Dr. Murphy has a family cottage on Caribou Island and has enjoyed many days of recreational boating and fishing in Caribou Harbour. As such, he is very familiar with the coastline, seabed and tidal conditions of the area of the proposed effluent outfall pipe. This submission is Dr. Murphy's independent and professional opinion on the proposed Effluent Treatment Facility by Northern Pulp.

Introduction

Figure 1: Ice thickness survey conducted by DFO in February 2013 immediately north of Caribou Island. The ice thickness is shown to exceed 3 m at a number of locations. (accessed from ftp://ftp.dfo-mpo.gc.ca/Sealce/Helicopter_Data/Gulf2013/7%20Gulf%202013%20Pictou%20large%20floe/).

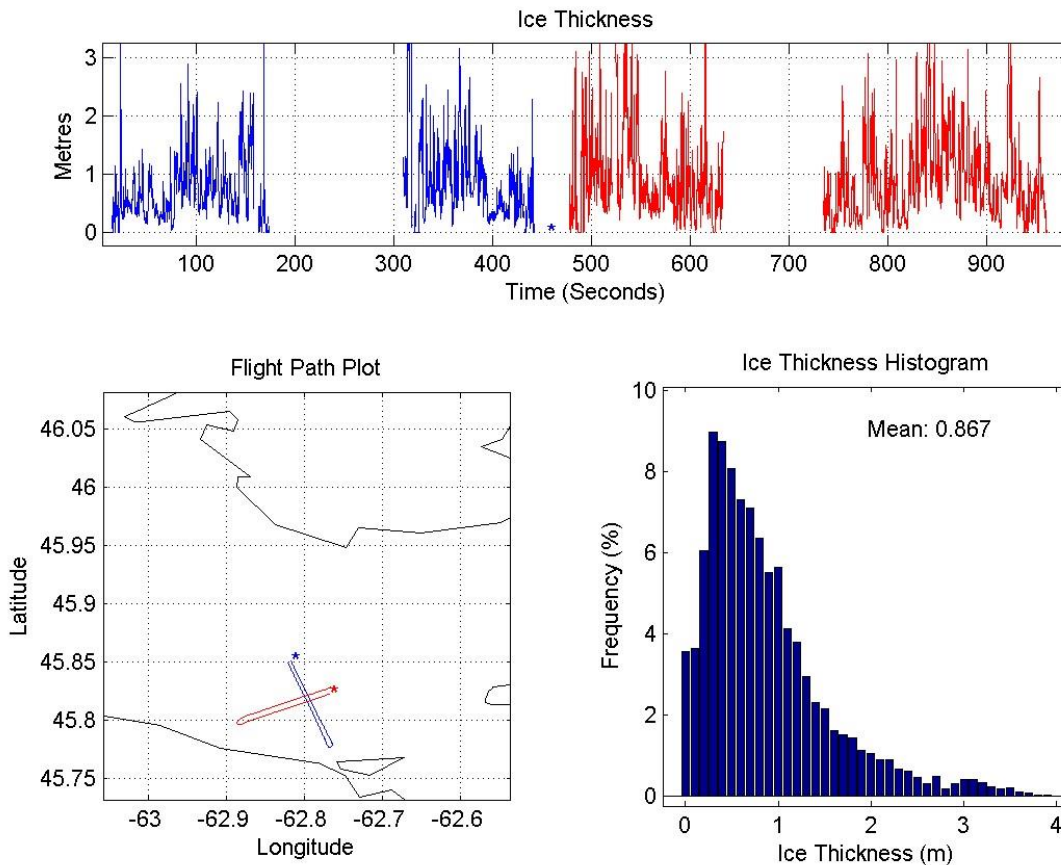
The Receiving Water Study (Appendix 4.2, Section 2.1.2.7) presents data from a DFO helicopter ice survey in February 2013. These data showed that the ice thickness had a mean thickness of approx. 0.7 m. However, the ice keels regularly exceed 2 m in that same dataset (see top panel of Figure 17 of Appendix 4.2). Furthermore, ice thickness surveys conducted by DFO during that same period (28 February 2013) immediately north of Caribou Island documents significantly thicker ice floe thicknesses with keel depths approaching 4 m (Figure 1).

These data are consistent with the values and analysis of Obert and Brown (2011)¹ and the thickness of ice in the Caribou Harbour can approach the burial depth proposed for the pipeline.

As a result of these observations, a burial depth of 3 m would not seem to represent a mitigation of the risk posed by ice floes (both scouring from the ice keel and grounding of the floe). Any number of processes could damage and rupture the pipeline and, in light of the pipe being buried 3 m, this damage would not be readily accessible or observable. A protracted leak could continue for a long period before being noticed potentially resulting in sustained damage to the marine ecosystem.

Figure 2: Map prepared for this submission showing the scalloped pattern of retrogressive erosion (in green) and the channelised gravity-driven sediment transport (red) along the edge of the dredged channel (red shading). The proposed pipeline is shown in pink.

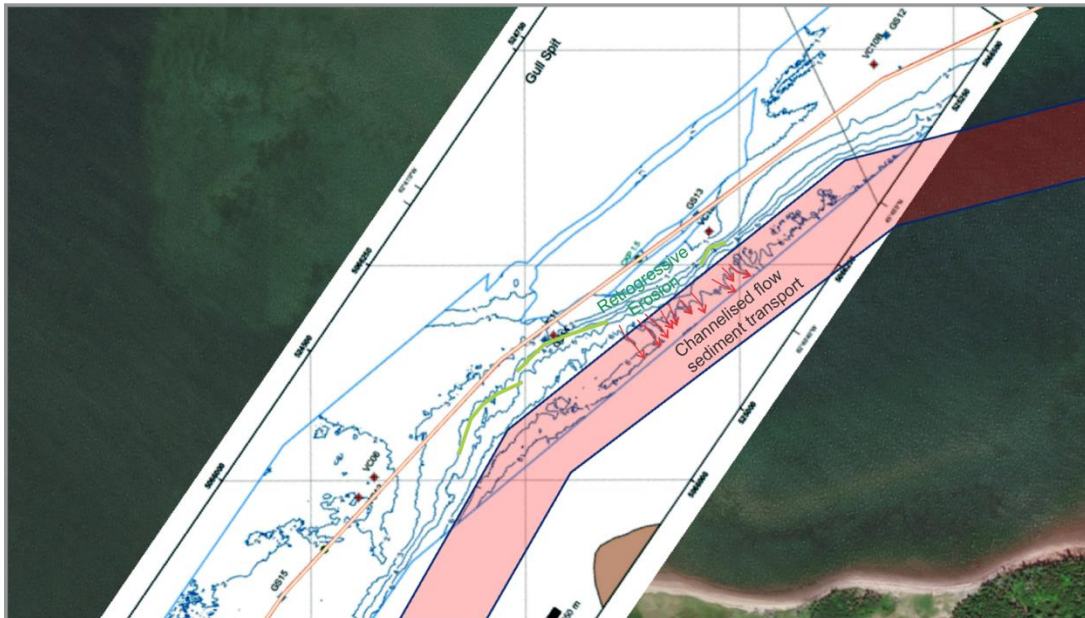
Multibeam bathymetry reveals the scalloped edge to the dredged channel which suggests retrogressive erosion (Figure 2). The eroded sediment undergoes gravity driven transport from the edge of the dredged channel downslope. The slope map in the Marine Geotechnical Survey Report (Figure 5.1.5 of Appendix 2.2) shows gradients exceeding 10° (possibly up to 20°) which, given the sediment type (sand/gravel – Enclosure 8 of Appendix 2.2), represents an unstable mobile seabed.

The proximity (within 20 m) of the unstable dredged channel slope to the proposed pipeline is cause for concern. Were there to be a larger slope failure, the seabed upon which the pipeline lays could give way. Even absent a catastrophic failure, the retrogressive erosion of the channel edge could eventually undermine the sediment base of the pipeline.

This sediment transport is the reason for ongoing dredging activity within the channel. This dredging is described in a project description by Public Works and Government Services Canada from 2017. The location of one of the areas targeted for dredging in that document coincides with the region described above. It seems plausible that this would be required again in the years to come. As such, significant machinery (barge-mounted mechanical dredges) would operate in the vicinity of the proposed pipeline posing a significant damage hazard.
